Title: Advisory Committee on Reactor Safeguards
 Thermal Hydraulic Phenomena and
 Reliability and PRA Subcommittees

Date: Tuesday, April 18, 2017

The purpose of today's meeting is to continue our discussions on the South Texas Project's Risk-Informed Approach to Resolve GSI-191 that was held in our joint subcommittee meeting on April 5th, two weeks ago. The subcommittee will gather information, analyze relevant issues and facts, and formulate proposed positions and actions as appropriate for consideration by the full committee.

Figure 1. A graphical representation of the categories ($TW_{Cat(D_i^{small})}$) in STP Class 1 pipes showing the categories above the smallest $D_i^{small} = 9.34''$ (Supplement 3).

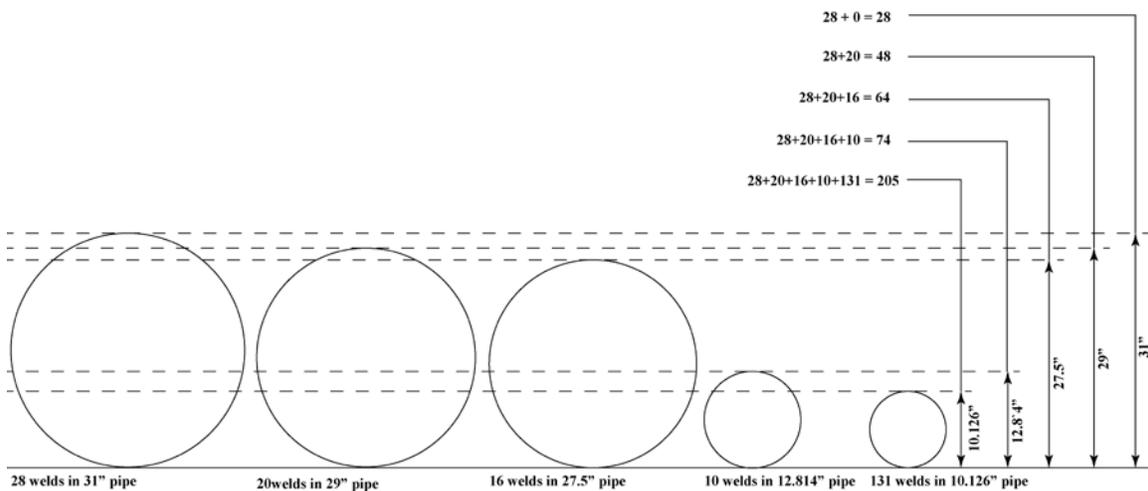
Question #2:

$$\Phi = \sum_{n=1}^{NP} \sum_{i \in R_n} F(D_i^{small}), \quad (4) \text{ from Supplement 3,}$$

that involve discrete pipe sizes. The change in D_i^{small} from Supplement 2 to Supplement 3 brought in a different pipe size (weld category.) A detailed inspection of intermediate results is provided in the following.

Because pipe sizes are built in discontinuous diameters, the potential for a break at any size will inherently reflect this discontinuity. Figure 1 is an illustration of how the $Cat(D_i^{small})$ are formulated for the extent of break sizes relevant to the Case 2 results.

Table 2 below implements (3) and (4) in Supplement 2 and Supplement 3 as an illustration of the behavior of the Single Train operation case (Case 2). Table 2 is created from a spreadsheet to show the primary inputs used to arrive at the results. As shown in the table, $f(D_i^{\text{small}})$ behaves as expected according to the break size reductions going from Supplement 2 to Supplement 3. That is, $f(D_i^{\text{small}})$ increases in an expected way between Supplements 2 and 3. Observe the first entry for example that goes from break size 9.55 down to break size 9.34, $f(9.55) = 1.09\text{E-}06$ and $f(9.34) = 1.136\text{E-}06$. These numbers can be looked up directly from the mean values in Section 4, Table 6, that are values taken from Table 19 in NUREG 1829. Implementing (4) (Attachment 1-3 Section 4.1 in the STP applications) for the same entries produces $F(9.55) = 5.32\text{E-}09$ (Supplement 2) and $F(9.55) = 5.52\text{E-}09$ (Supplement 3) as expected.
